AGENDA
SPECIAL JOINT VILLAGE BOARD-PLAN COMMISSION MEETING
RICHFIELD VILLAGE HALL
4128 HUBERTUS ROAD, HUBERTUS, WISCONSIN
AUGUST 16, 2012
7:00 P.M.

VILLAGE OF RICHFIELD
 PLAN COMMISSION COMMUNICATION FORM
 MEETING DATE: August 16, 2012

SUBJECT: Modification of access easement for Parcel 3 of CSM 4718 (parcel V10-088100J) involving Parcel 4 of CSM 4718 (parcel V10-088100K)

SUBJECT: Signage plan for First National Bank of Hartford located at 1297 STH 175 (Parcel V10-088100J)

EASEMENT EXHIBIT A

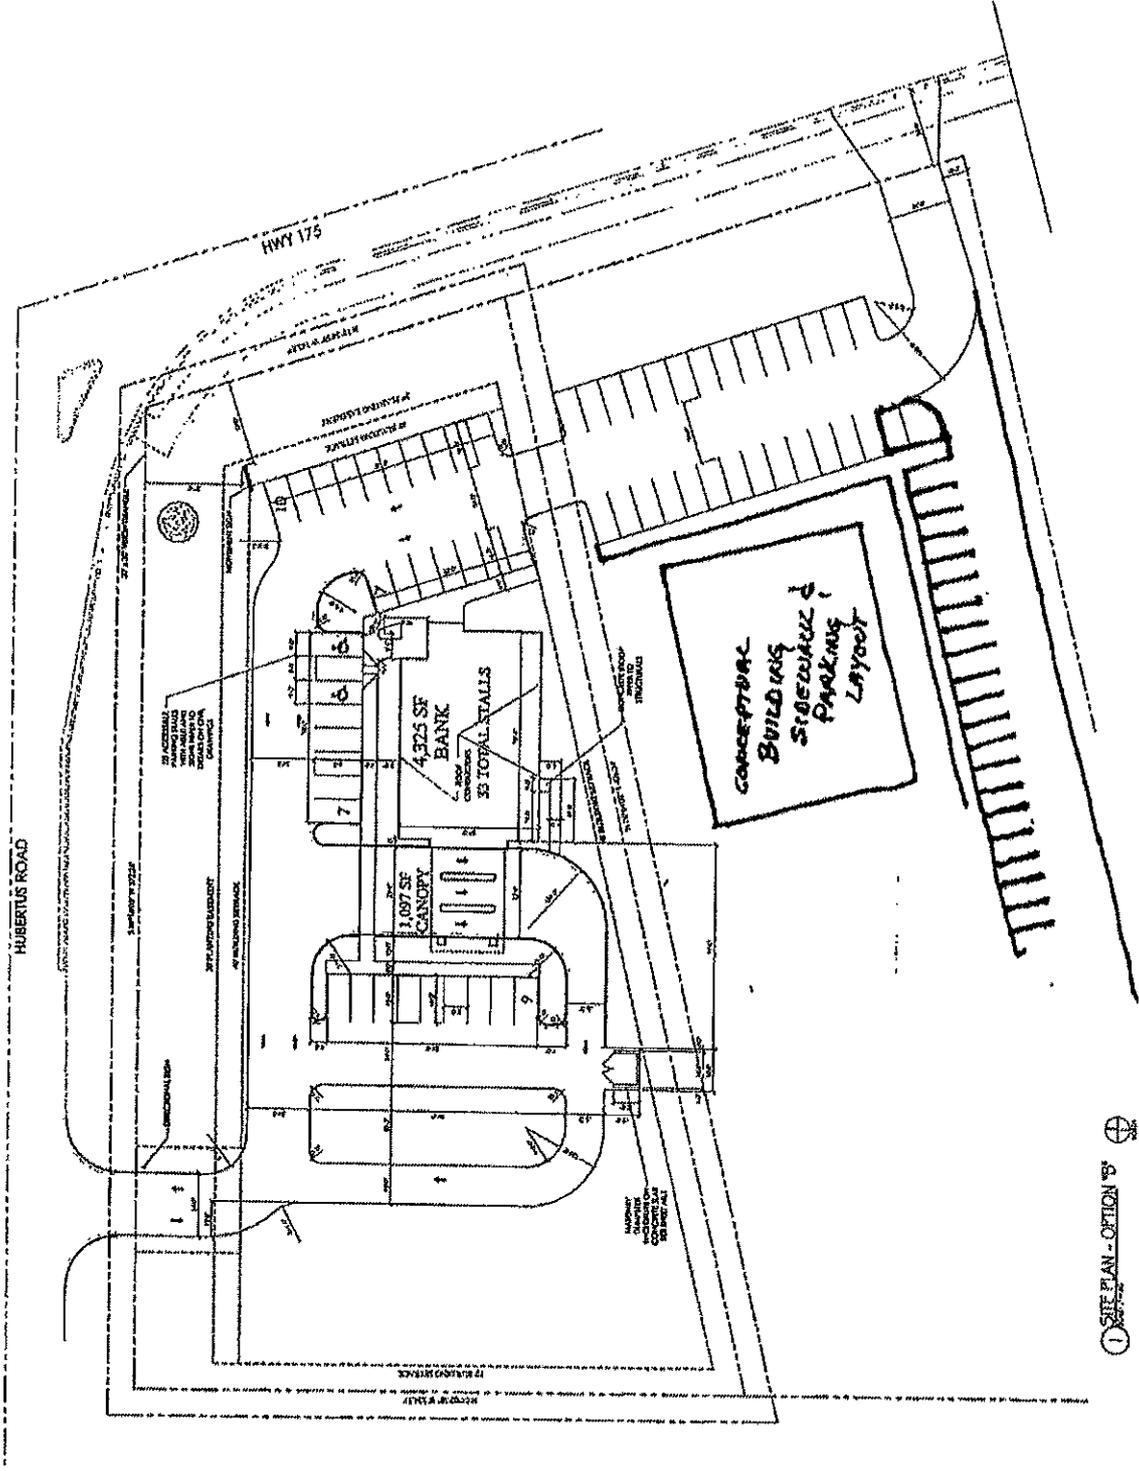
The Plan Commission recently reviewed a SBOP application for First National Bank of Hartford's new building on the corner of STH 175 and Hubertus Road. Since that time, WisDOT has informed them that the access point on STH 175 they had planned on using (and which was shown on the approved site plan) may not be used. The DOT has approved an access further to the south.

Two parcels are involved: Parcel 3 of CSM 4718, referred to herein as the "bank parcel" and Parcel 4 of CSM 4718, which is located to the south of the bank parcel, referred to herein as the "Weyer parcel." Exhibit A shows the two subject properties and the existing easement and the proposed easement on the Weyer parcel.

Motion to recommend to the Village Board the termination of the existing easement created by CSM 4718 for the benefit of Parcel 3 and the establishment a new easement over Parcel 4 for the benefit of Parcel 3 with the understanding that (1) the site plan reviewed as part of this discussion is conceptual in nature and that the layout may not necessarily comply with the zoning requirements at the time the property is developed, (2) construction of the access road and parking stalls on Parcel 4 shall not create a hardship for a variance in that this design was self-imposed, and (3) the Village Administrator is authorized to review and approve those documents that must be recorded at the register of deeds office as to form and content.

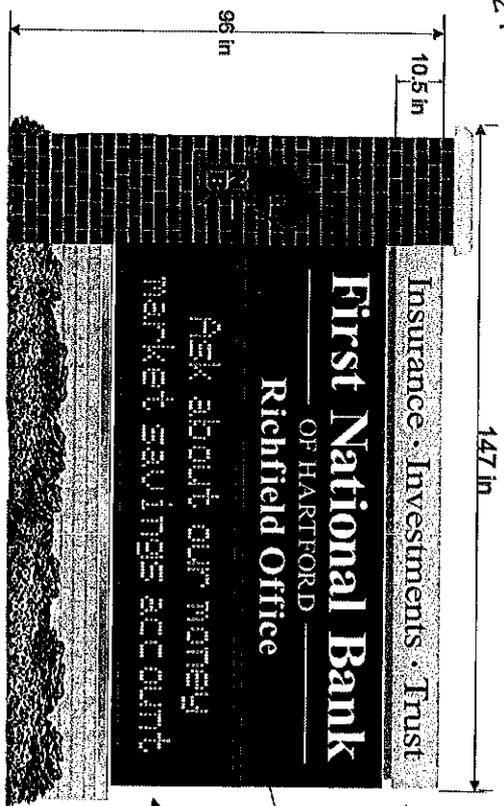
1. Monument sign – This sign consists of an unlit sign face (at the top), an internally lit sign face (in the middle) and an electronic message center (EMC) (at the bottom). The EMC will have a black background with amber lettering. The sign complies with all dimensional requirements regarding height of the sign and sign area. The face of the internally lit sign will be opaque as required by Sec. 62.02(A)(1)(e). The petitioner is aware of the requirements related to how often the message can change (5 minute timeframe) and that lighting levels may not exceed 5,000 NITs during daylight hours and 500 NITs at night (sec. 62.01(I)). This sign is to be located in the northeast corner of the property in the location generally depicted on sheet A0.2 (attached). As of this writing, staff has not been able to verify whether the proposed location complies with any locational requirements that may apply with the State Department of Transportation. It is anticipated staff will be able to verify compliance prior to the Plan Commission meeting.

Motion to approve the signage plan as submitted provided the location of the monument sign complies with all DOT requirements relating to the location of the sign along STH 175.

North Elevation

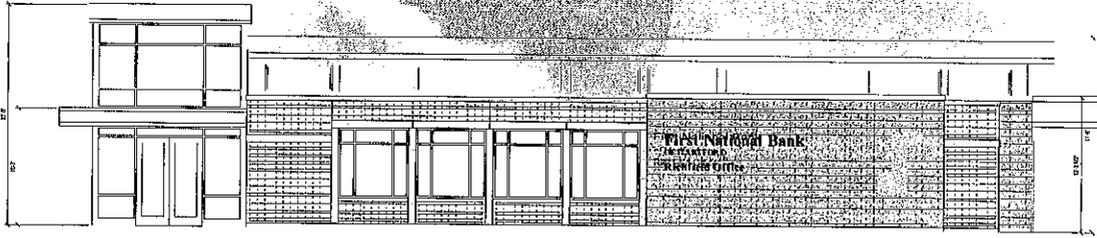
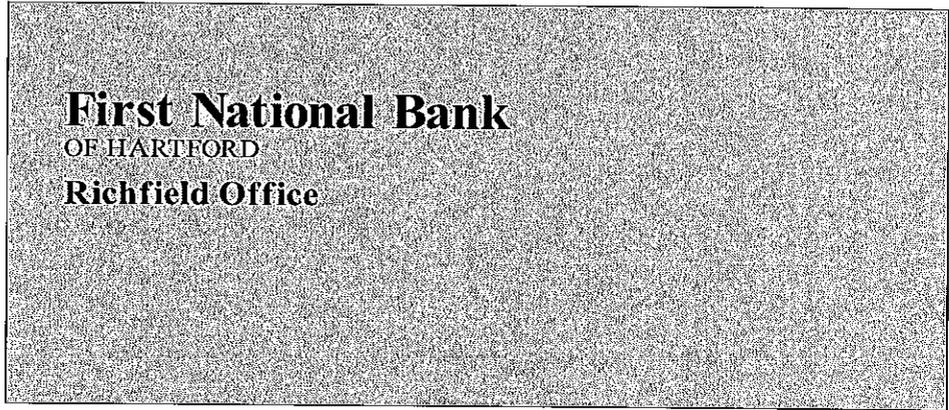
3. Unlit wall signs – Wall signs will be displayed on the north, east, and south building elevations. Based on the building frontage, 108 sq. feet are allowed on the east elevation, 46 sq. feet are proposed; 172 sq. feet are allowed on the north elevation, 65 sq. feet are proposed; and 24 sq. feet will be located on the south face of the corner tower. The size of the proposed wall signs will comply with sign code requirements.
